project
DORMER EXTENSION TO
EXISTING LOFT

status Building Regs

drawing
PROPOSED PLAN &
ELEVATIONS.

dwg no 22-01 07. rev C

GROUND FLOOR PLAN 1:100

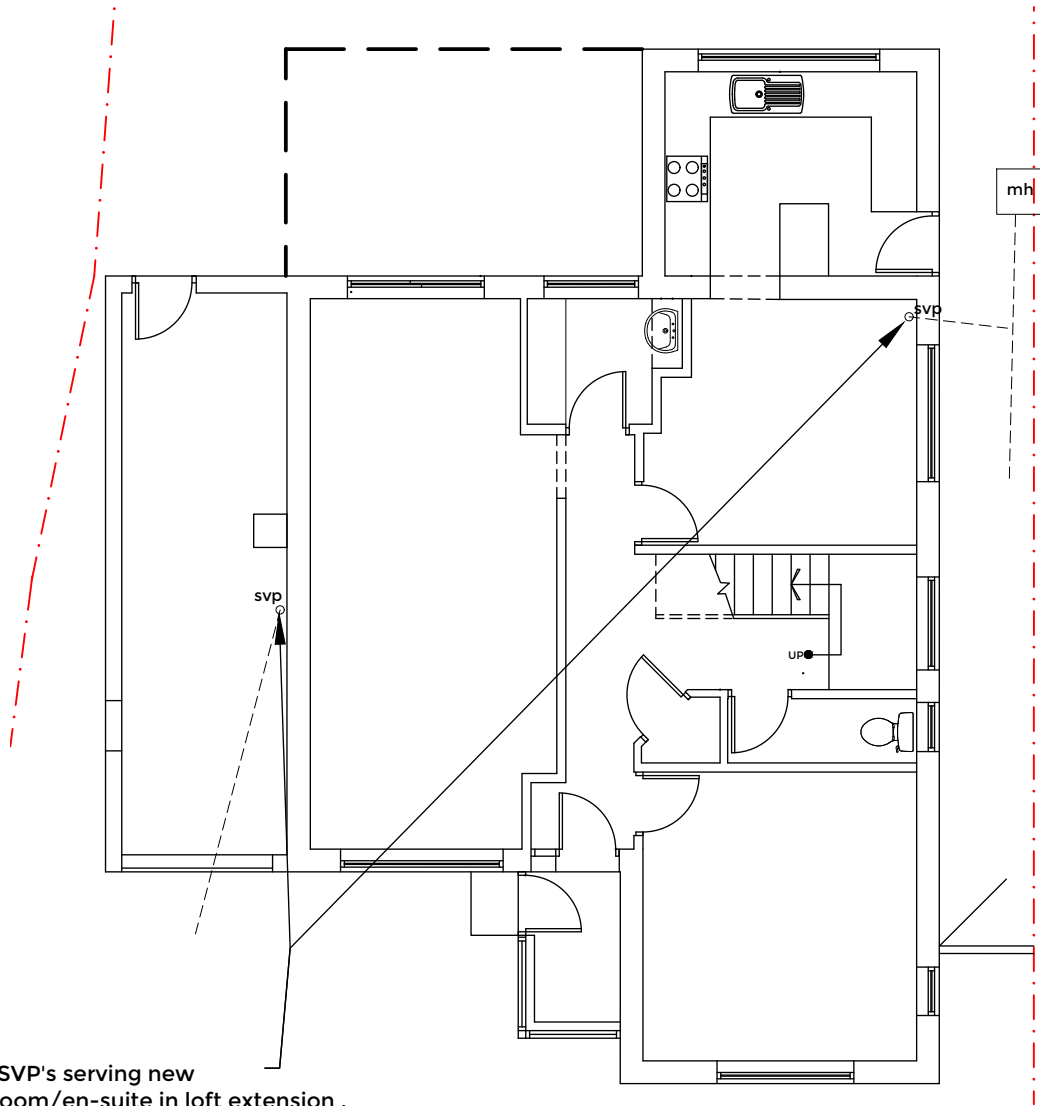
AMENDMENT-Top hung opening light with restrictor. Opening light to be a minimum area of 0.33m2 with minimum height and width of 450mm. The bottom of the openable window to be a maximum of 1100mm above the floor. 100mm restriction to opening. Override facility on restrictor for emergency escape to give full opening.

Ensure chimney/flue outlet is 1 metre min above opening window within 2.3m of chimney. If not build up chimney/flue.

PROPOSED SIDE ELEVATION 1:100

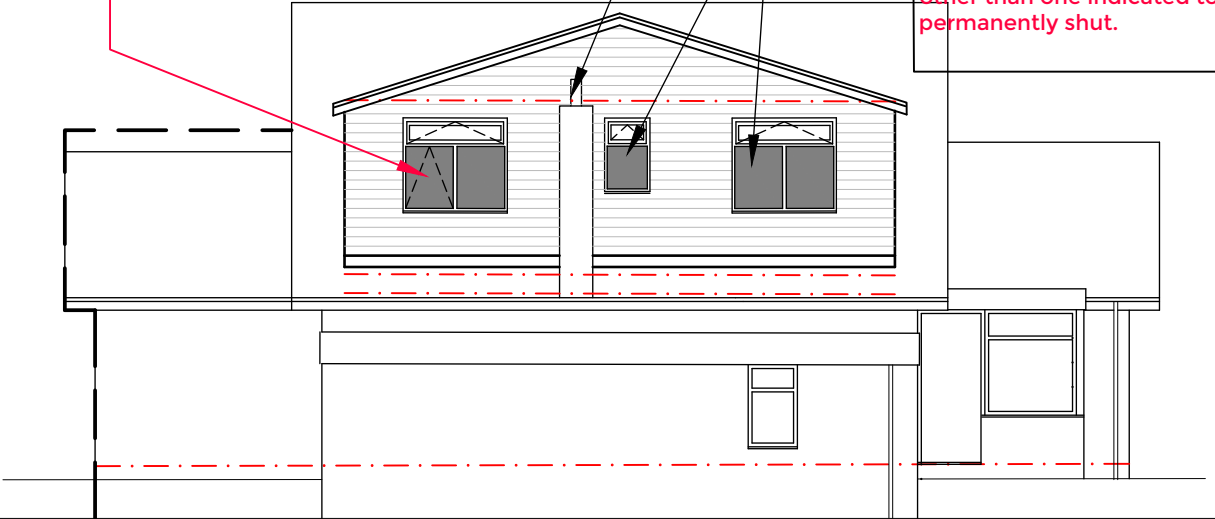
Windows to side elevations to have frosted/obscure glass to a height of 1.7m minimum above finished first floor level.No opening lights below 1.7m. Any installed windows with opening lights other than one indicated to be secured permanently shut.

PROPOSED SIDE ELEVATION 1:100

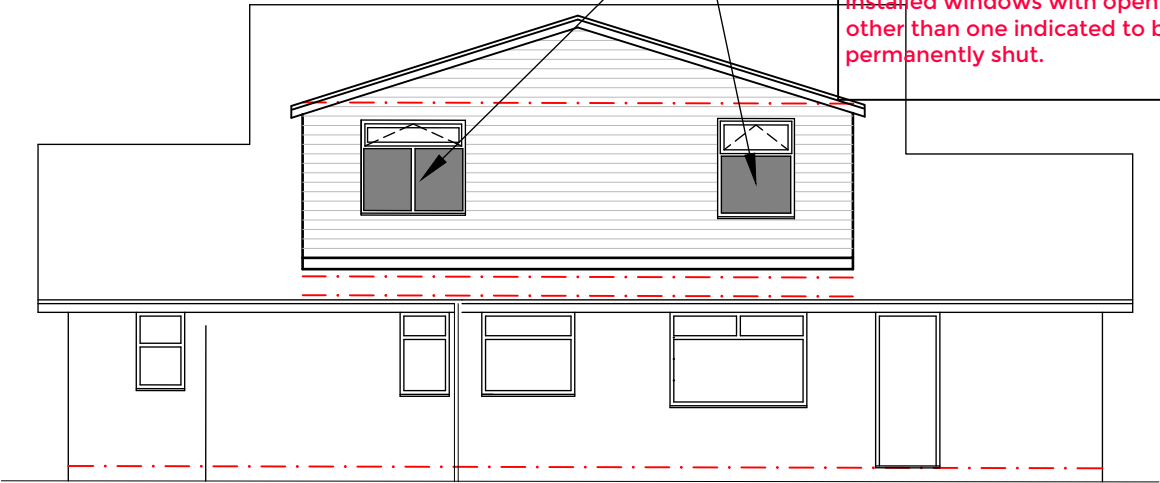
Windows to side elevations to have frosted/obscure glass to a height of 1.7m minimum above finished first floor level.No opening lights below 1.7m. Any installed windows with opening lights other than one indicated to be secured permanently shut.
